# Siterwell Electronics Co., Limited

## NON-CONFORMANCE LETTER REPORT

TYPE OF TESTING: RCM  
PRODUCT TYPE: SMOKEALARM  
MODEL: GS529-P08; GS529-P07

210802025GZU-NCLR001

GS529-P07:

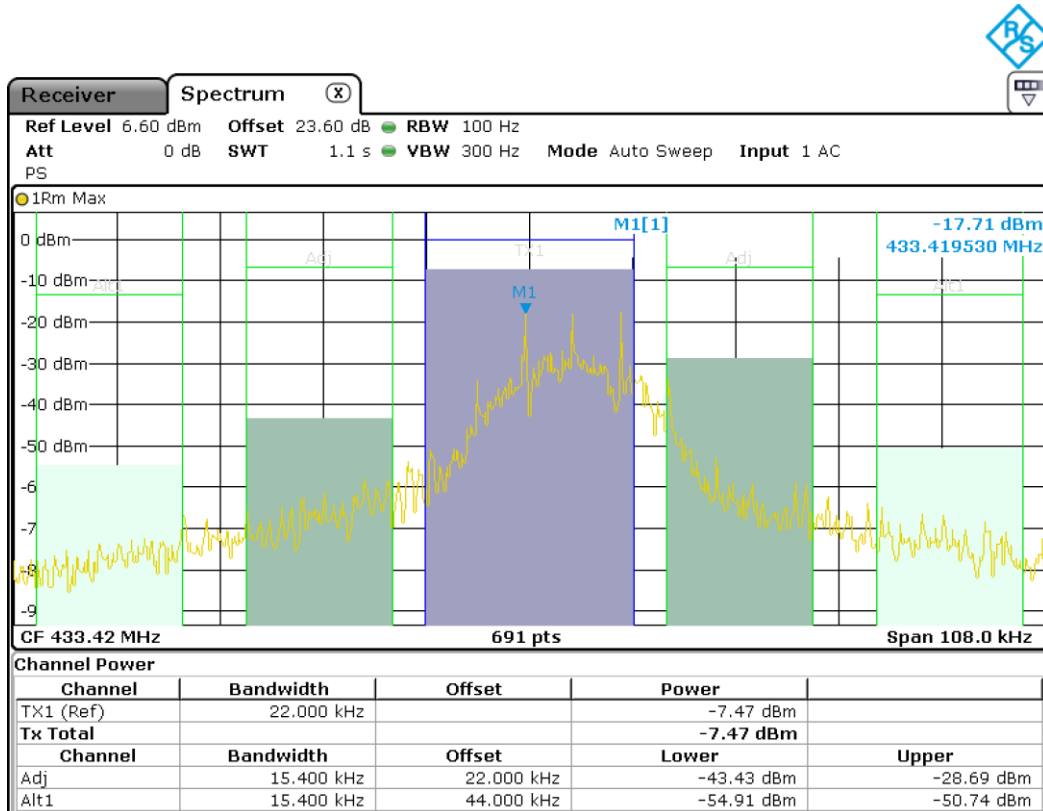
1. **Adjacent channel power**

EUT operation mode: Normal condition Transmitting

| Test frequency:<br>433.42MHz | Reading   | Limit   |
| ADJ channel                  | -24.71dBm | ≤-37dBm |
| Alternate ADJ channel        | -38.78dBm | ≤-40dBm |
